dsPIC33FJ06GS001/101A/102A/202A and dsPIC33FJ09GS302 Family Silicon Errata and Data Sheet Clarification

The dsPIC33FJ06GS001/101A/102A/202A and dsPIC33FJ09GS302 family devices that you have received conform functionally to the current Device Data Sheet (DS75018C), except for the anomalies described in this document.

FIGURE 1: TIMING DIAGRAMS FOR CENTER-ALIGNED AND EDGE-ALIGNED MODES

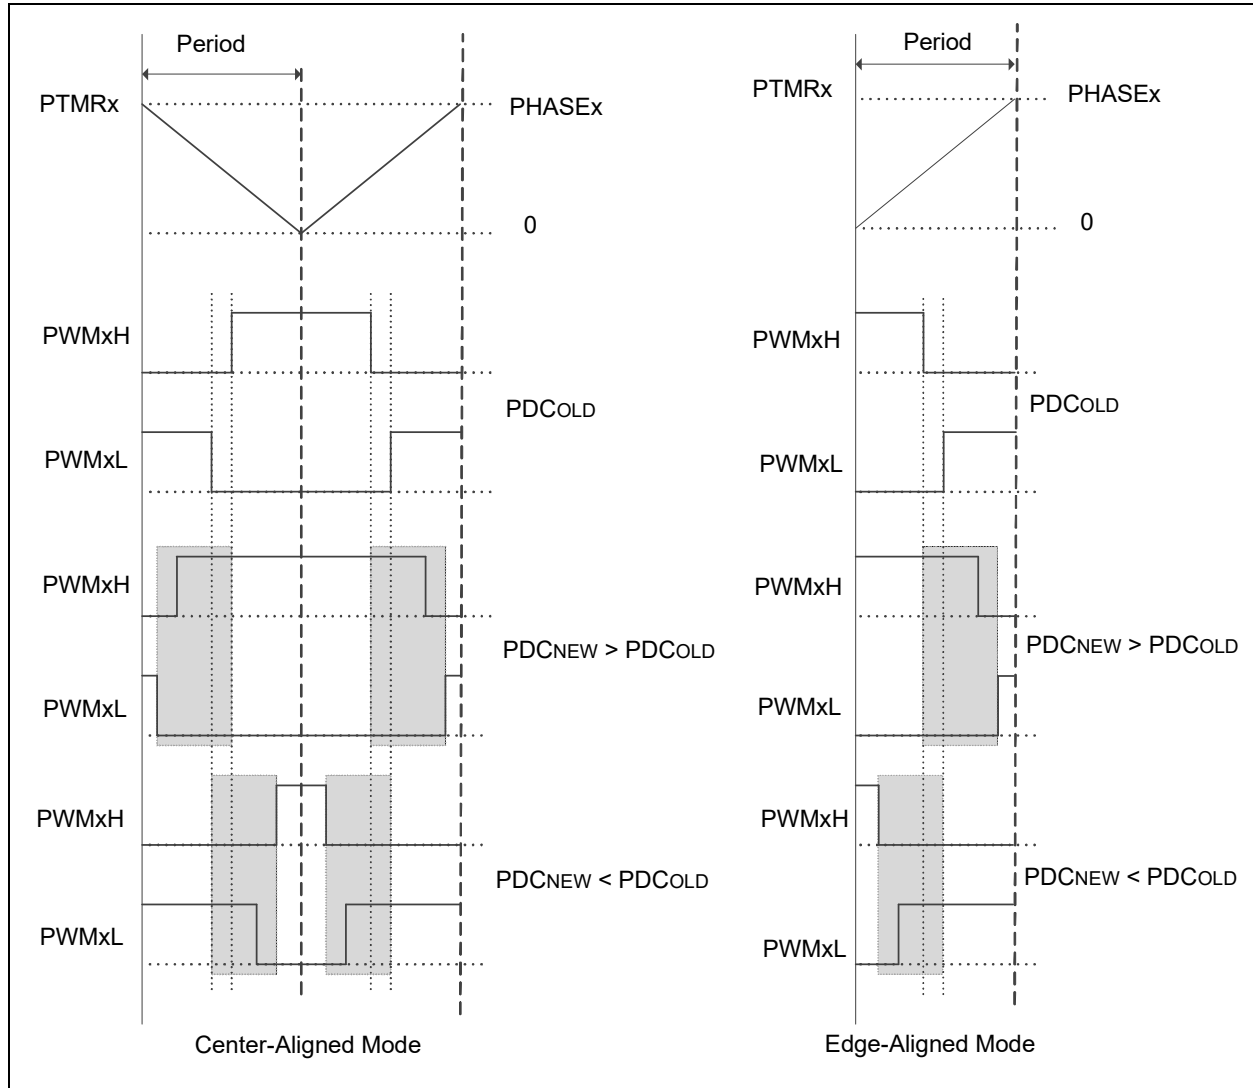
The PWMx generator may not assert dead time on the edges of transitions. This has been observed when all of the following conditions are present:

- The PWMx generator is configured to operate in Complementary mode with the independent time base or master time base;
- Immediate update is enabled; and
- The value in the PDCx register is updated in such a manner that the PWMxH and PWMxL outputs make an immediate transition.

The current duty cycle, PDCOLD, newly calculated duty cycle, PDCNEW, and the point at which the write to the Duty Cycle register occurs within the PWMx time base, will determine if the PWMxH and PWMxL outputs make an immediate transition. PWMxH and PWMxL outputs make an immediate transition if the Duty Cycle register is written with a new value, PDCNEW, at a point of time when the PWMx time base is counting a value that is in between PDCNEW and PDCOLD. Additionally, writing to the Duty Cycle register close to the instant of time where dead time is being applied may result in reduced dead time, effective on the PWMxH and PWMxL transition edges.

In [Figure 1](#) (following page), if the duty cycle write occurred in the shaded box, then PWMxH and PWMxL will make an immediate transition without dead time.

None. However, in most applications the duty cycle update timing can be controlled using the TRIGx trigger or Special Event Trigger such that the above mentioned conditions are avoided altogether.

FIGURE 2: ISSUE EXAMPLE FOR REDUNDANT OUTPUT MODE

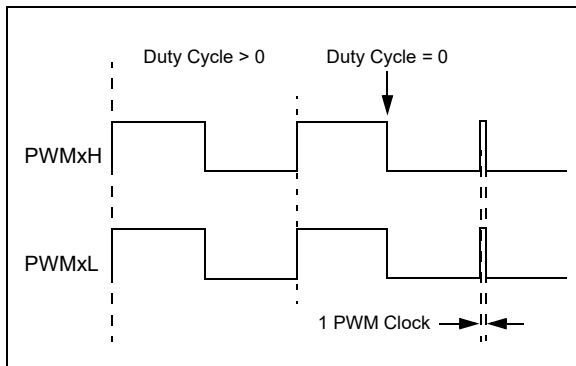
In Redundant Output mode ($\text{IOCONx}[11:10] = 01$) and Push-Pull Output mode ($\text{IOCONx}[11:10] = 10$) with the Immediate Update Enable bit ($\text{PWMCONx}[0] = 0$) disabled, when the Duty Cycle register is updated from a non-zero value to zero, a glitch pulse of a width equal to one PWM clock will appear at the next PWM period boundary, as shown in Figure 2 (for the Redundant Output mode). The Duty Cycle register refers to the PDCx register if $\text{PWMCONx}[8] = 0$ or the MDC register if $\text{PWMCONx}[8] = 1$.

If the application requires a zero duty cycle output, there are two possible work around methods:

1. Use the PWM override feature to override the PWM output to a low state instead of writing to the Duty Cycle register. In order to switch back to a non-zero duty cycle output, turn off the PWM override. The override-on and override-off events must be timed close to the PWM period boundary if the IOCONx register has been configured with $\text{IOCONx}[0] = 0$ (i.e., output overrides through the $\text{OVRDAT}[1:0]$ bits occur on the next CPU clock boundary).
2. Enable the Immediate Update Enable bit ($\text{PWMCONx}[0] = 1$) while configuring the PWM module (i.e., before enabling the PWM module, $\text{PTCON}[15] = 1$). With the Immediate Update enabled, writes to the Duty Cycle register can have an immediate effect on the PWM output. Therefore, the duty cycle write operations must be timed close to the PWM period boundary in order to avoid distortions in the PWM output.

FIGURE 3: ISSUE EXAMPLE IN PUSH-PULL MODE

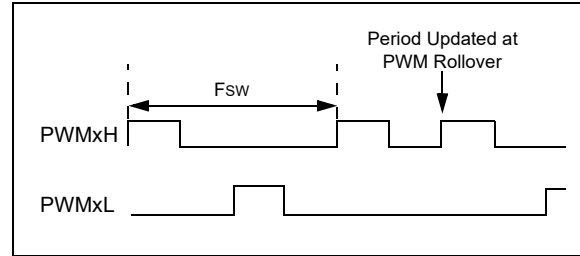
When the PWM module is configured for Push-Pull mode ($\text{IOCONx}[11:10] = 10$) with the Enable Immediate Period Updates bit enabled ($\text{PTCON}[10] = 1$), a write to the Period register that coincides with the period rollover event may cause the push-pull output logic to produce back-to-back pulses on the PWMx output pins (Figure 3).

Use either the PWMx Special Event Compare (SEVTCMP) or PWMx Primary Trigger Compare Value (TRIGx) to generate a PWM Interrupt Service Routine (ISR) near the start of the PWM cycle. This ISR will ensure that period writes do not occur near the PWM period rollover event.

FIGURE 19-2: ADC BLOCK DIAGRAM FOR THE dsPIC33FJ06GS101A DEVICE

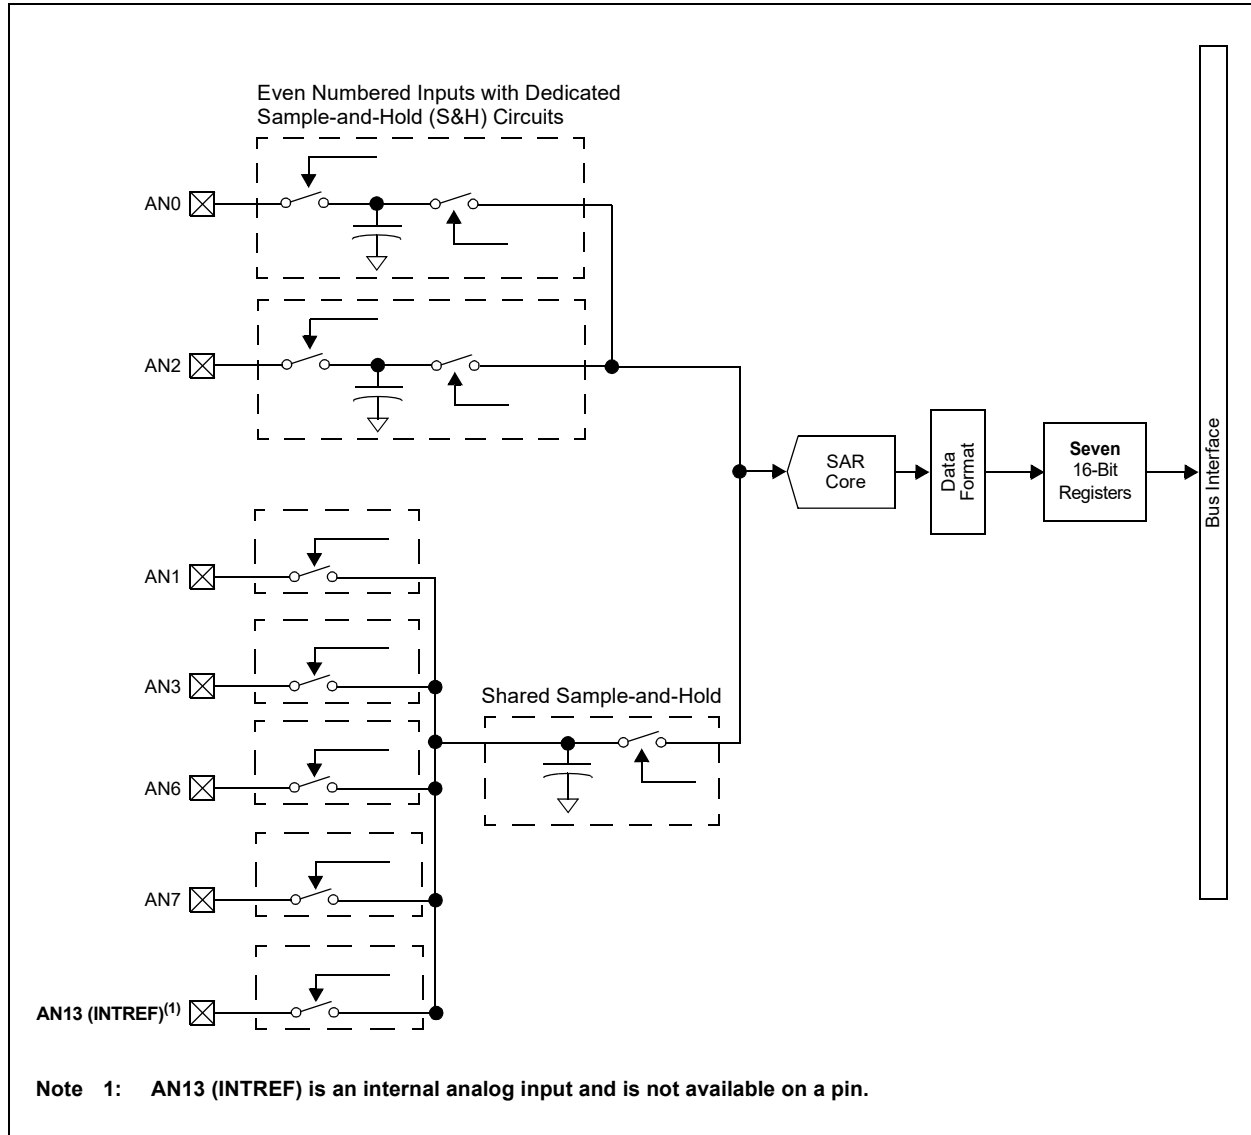
In [Figure 19-2](#) and [Figure 19-3](#), AN13 has been added and the number of output registers has been changed from eight to seven.

FIGURE 19-5: ADC BLOCK DIAGRAM FOR THE dsPIC33FJ09GS302 DEVICE

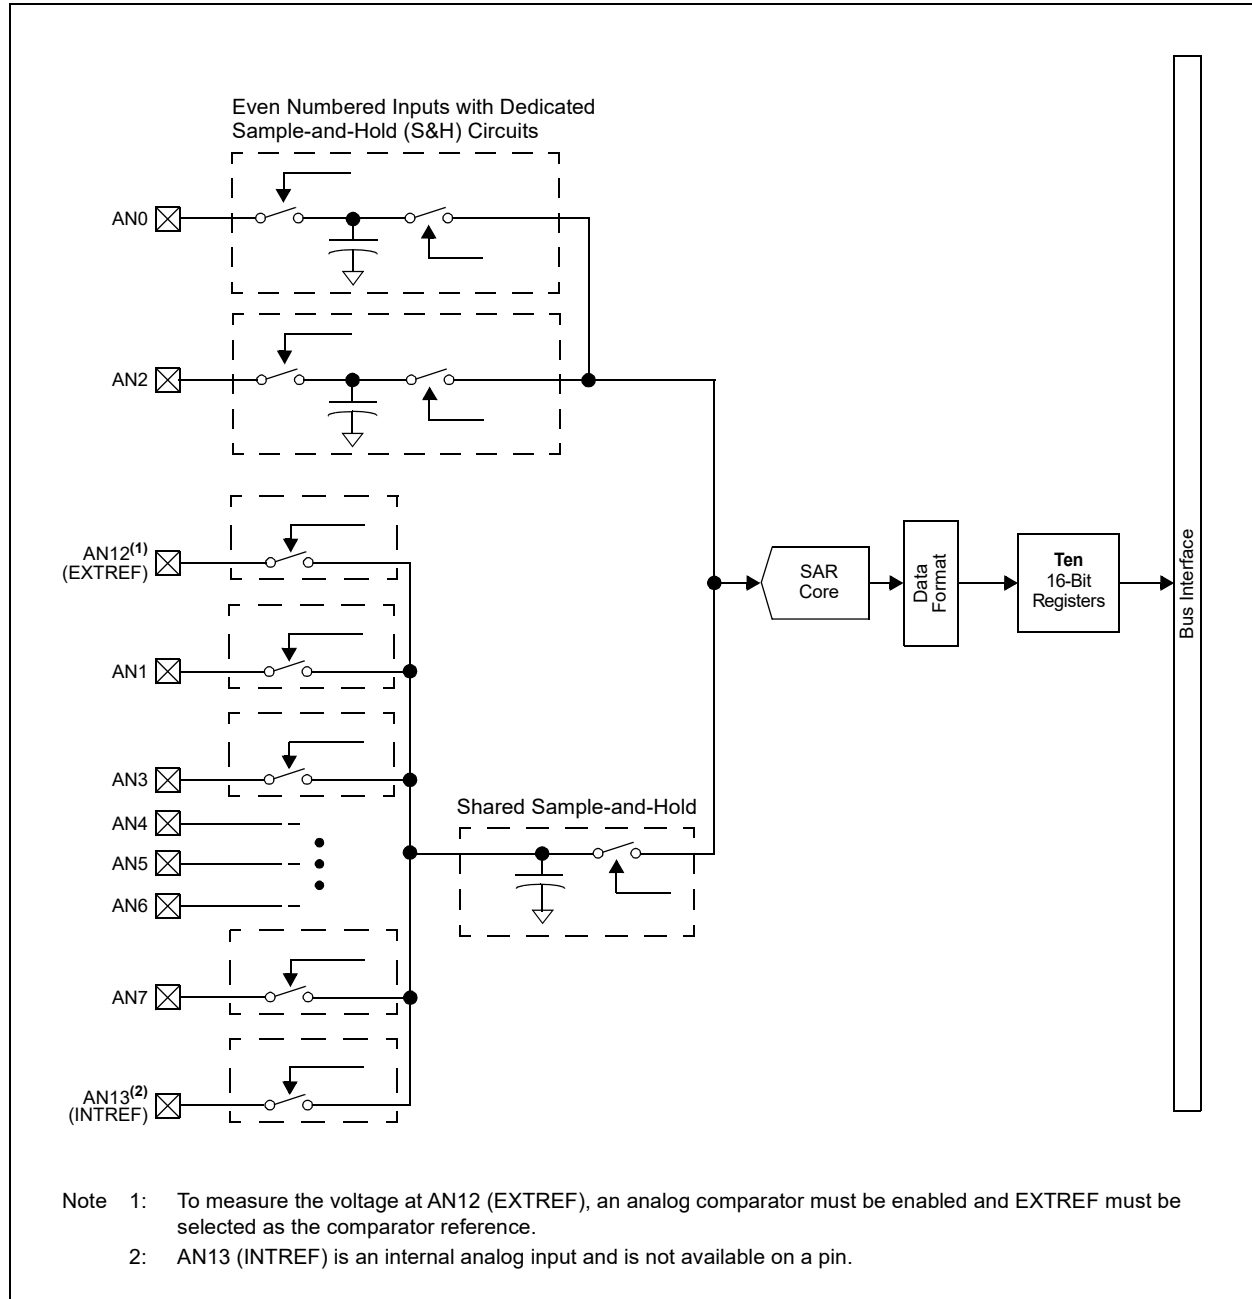
In [Figure 19-5](#), the number of output registers has been changed from eight to ten. The changes are shown in bold below:
